Sumter City-County Planning Commission

SD-12-01, Deschamps Road Subdivision (County)

Request: A request for preliminary plat approval to develop a 108 lot residential subdivision.

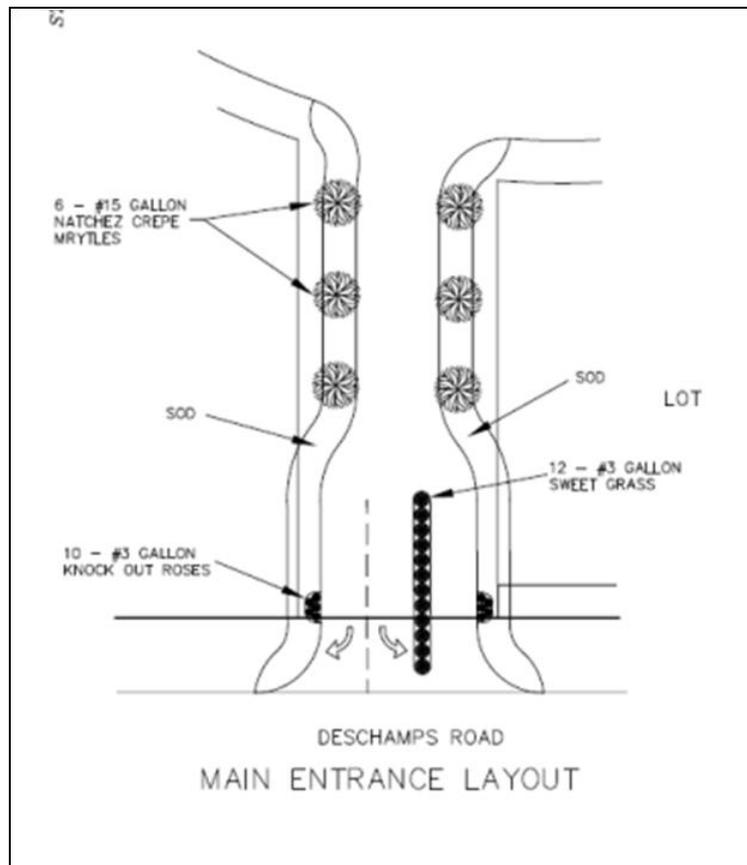
The applicant has submitted a detailed landscaping plan that addresses planting within stormwater management areas, along the Deschamps Rd. street front as well as the northernmost and southernmost boundaries of the development.

- a. *Deschamps Rd. Street Front Planting* – all street front buffer plantings shall be installed prior to final plat approval for the first phase of development.

- b. *Primary Subdivision Entrance* – all specified plantings shall be installed prior to final plat approval for the first phase of development.
 - c. *10 ft. Buffer on the North and South boundary of the development* – these buffer areas are comprised of existing vegetation. These areas are not to be cleared, Final certificate of occupancy shall not be issued for any individual lot until the buffer area is inspected and found to be in-tact, should existing vegetation be removed during construction, said buffer area shall be replanted prior to issuance of CO.

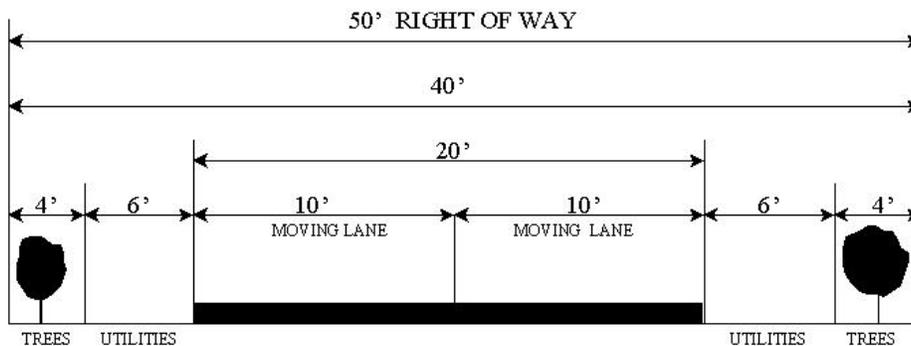
The main entrance in to the development will also be planted according to the following graphic:

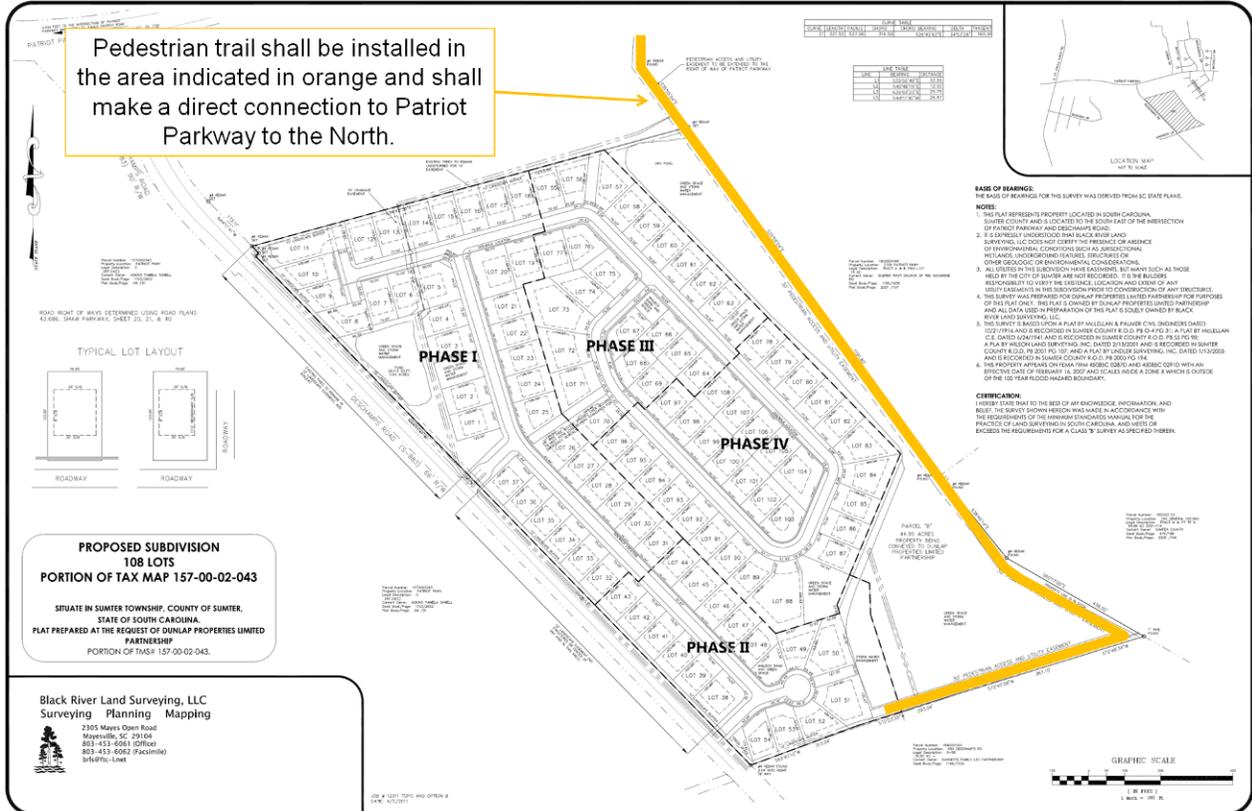
- a. The pedestrian trail shall be graded and installed prior to issuance of final plat on Phase III of the development in the location shown in the graphic below.
